Responses to Reveiwer 1

This manuscript focused on analyzing variations and risk of extreme precipitation events in the Gangjing river basin. The authors used sub-daily records and investigated the changes and temporal scales of extreme precipitation with gamma parameters and M-K test. The research is suitable for Natural hazards and earth system.

Comments: In this paper, extreme precipitation statistics are examined for Ganjiang river basin in China. This work contains interesting results in the field of risks of extreme events in a changing climate, though, in my opinion, there are significant problems that need to be addressed. Thus, I would recommend a major revision of the manuscript according to the following comments, which I hope the authors will find useful.

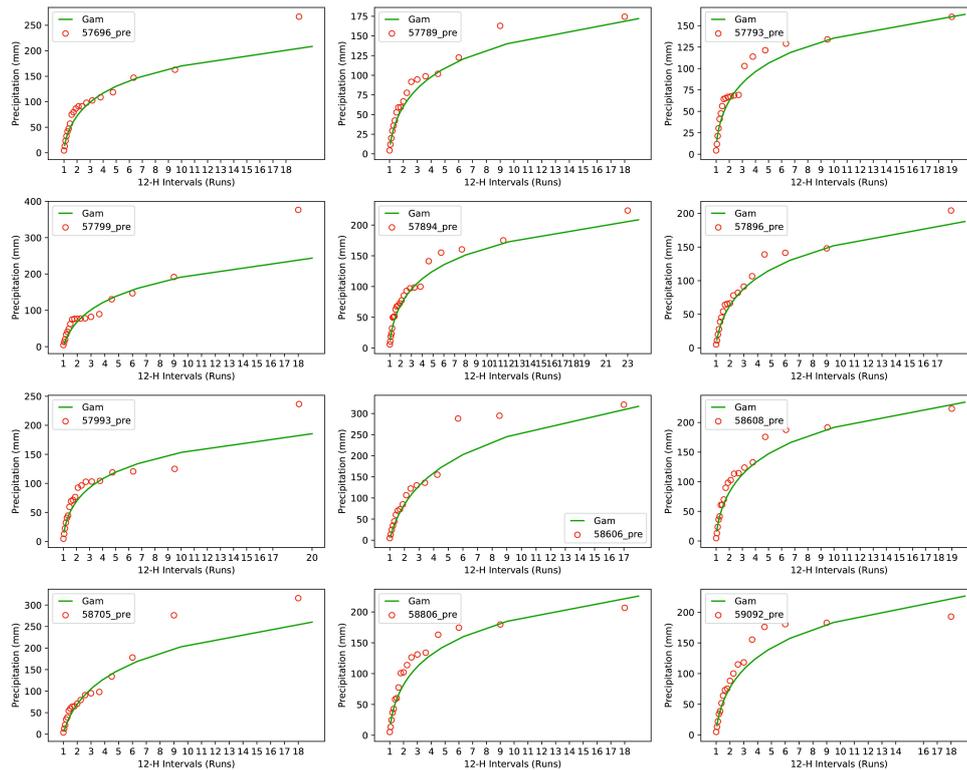
15. Lines 231-232: The term “run” firstly appears here without a previous explanation. I assumed it refers to the 12-h intervals of precipitation and under this assumption I read the rest of the paper (I hope I got it right). Moreover, the sentence is confusing: What do the phrases “on the standard of an event” and “with the purpose to keep independent for time series analysis” mean? In any case, the choice to work with 12-h values is not justified. Please elaborate more on this choice.

Response: Sorry for the confusion. Yes. Run means number of durations for precipitation in this paper,, we revised this part as:

“Runs of 12-H precipitation in each station were calculated with records of precipitation $>0.1\text{mm}$. Runs are defined as consecutive precipitation events for time series analysis in this paper. 1-run refers to a precipitation event recorded in 12 hours. 2-run refers to an event with precipitation recorded in two consecutive 12-hour intervals, and so on. If no precipitation is recorded at an interval greater than 12 hours, precipitation is defined as discontinuous and divided into two runs. This definition helps keep the calculated events independent.”
